W3F1-2015-0075

**SUBJECT:** Update to Responses to Request for Additional Information Regarding  
Adoption of National Fire Protection Association Standard NFPA 805 License  
Amendment Request (LAR)  
Waterford Steam Electric Station, Unit 3 (Waterford 3)  
Docket No. 50-382  
License No. NPF-38

**Updated FPE RAI 10 Response**

SKETCH (Not to Scale)  
RAB -4' Elevation

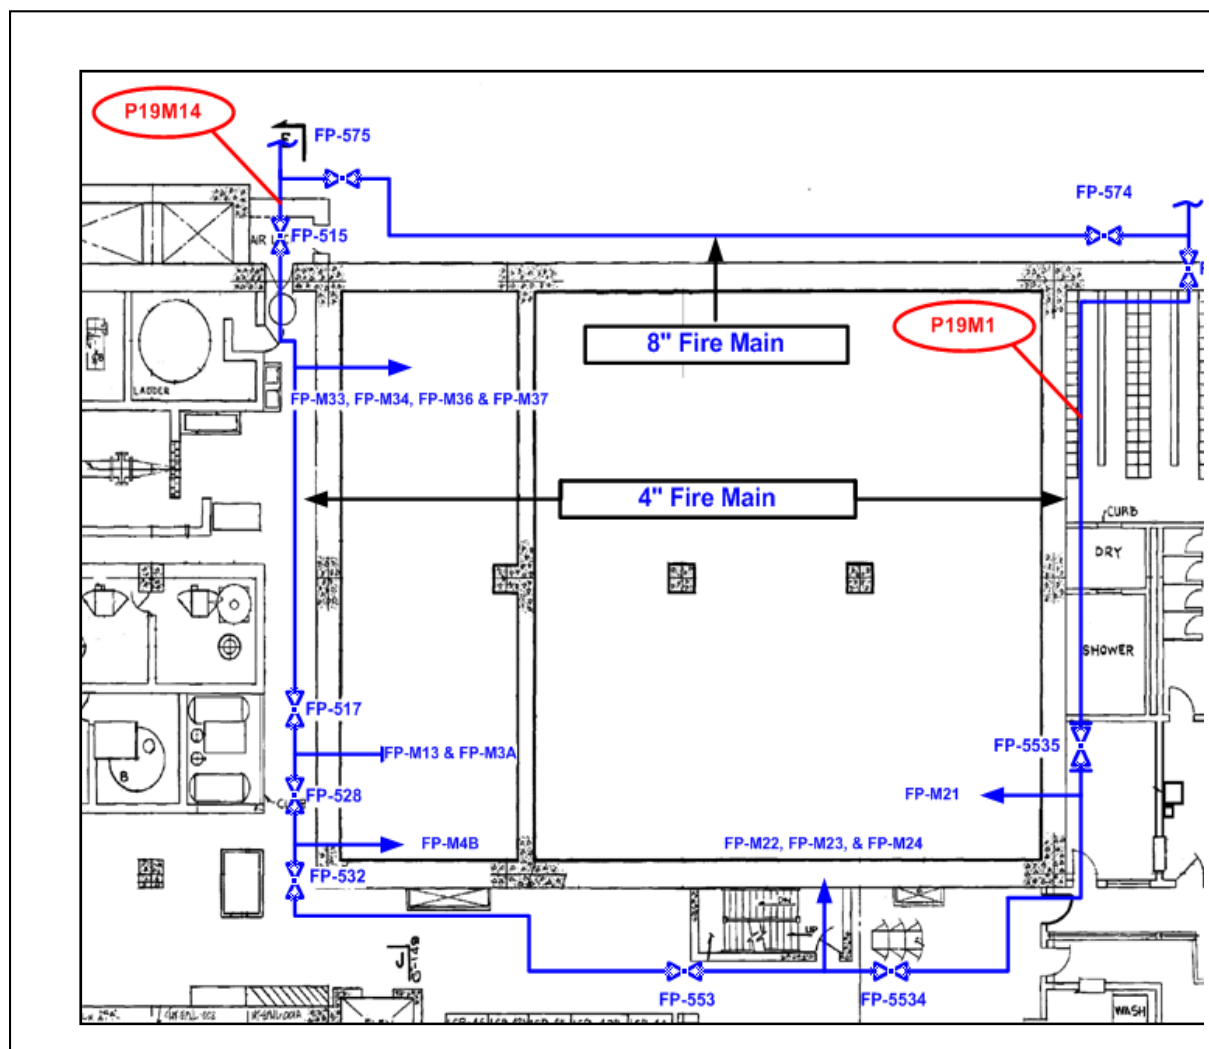
*Attachment L, Approval Request 6 -A deviation from NFPA 805 Section 3.5.1 is requested for several plant areas where the fire water supply demand is not met with the least demanding portion of the main loop out of service. Please justify this deviation to include a discussion of the following:*

- a. The location of this 4" loop section.*
- b. The procedures in place to mitigate.*
- c. The capacity of the three sprinkler systems given the least demanding portion of the main loop is out of service.*

An 8 inch diameter fire main is routed through the Reactor Auxiliary Building (RAB) and connects to the outside 10 inch diameter underground fire main loop on both the east and west sides of the RAB. This 8 inch fire main traverses east/west near the south wall of Fire Area RAB 32 (RAB -4' Elevation). The 4 inch fire main loop, addressed in Attachment L Approval Request 6, connects to the above described 8 inch fire main in Fire Area RAB 32 (approximately 3 feet west of column line 10AZ and approximately 2'-8" north of column line L). The 4 inch loop then traverses south into Fire Area RAB 30, then west and north in Fire Area RAB 31 around the Condensate Storage and Refueling Water Pools before re-entering Fire Area RAB 32 (RAB -4'Elevation) over fire door D-161 (along column line L between column lines 5A and 6A). The 4 inch loop then connects back into the 8 inch fire main loop in RAB 32 (approximately 7'-2" west of column line 6A and approximately 11'-6" north of column line L). This 4 inch loop is approximately 300 linear feet of pipe in length and runs in the overhead areas of the -4 foot elevation in the RAB. See Sketch below for general routing of the 8 and 4 inch fire mains discussed above.
